**Re: Ingham Property Group Master Plan – 475 Badgerys Creek Road, Bradfield –
Liverpool City Council Submission**

IPG Master Plan – 475 Badgerys Creek Road, Bradfield – Council Submission

Attachment 1 – Liverpool City Council – Detailed Submission

Figure 21 - Liverpool Infrastructure Plan

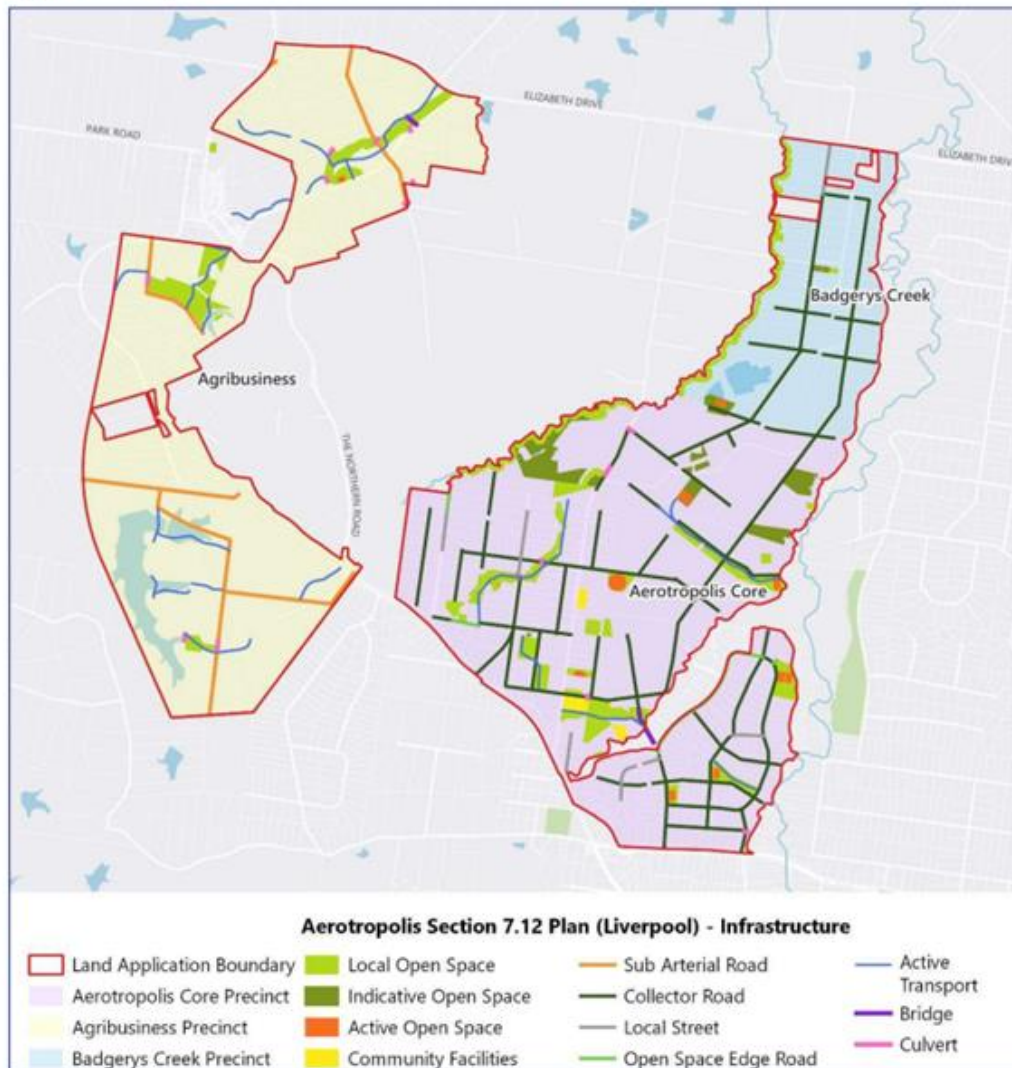
Confirmation is required regarding the collector roads and its length on the subject site as per Aerotropolis s7.12 Contributions Plan 2024 as well as delivery mechanism.

It appears that there is a discrepancy on the length and locations of collector roads between “Figure 6 – Local Infrastructure” (p19 of the “Draft infrastructure delivery strategy”) and Figure 21 Liverpool Infrastructure Plan (in the Liverpool 7.12 Contributions Plan) see:

The 7.12 contributions plan has only allowed for road provision in the mapped locations and in accordance with the road length mapped. The amendments proposed under the Masterplan will impact on this mapping.
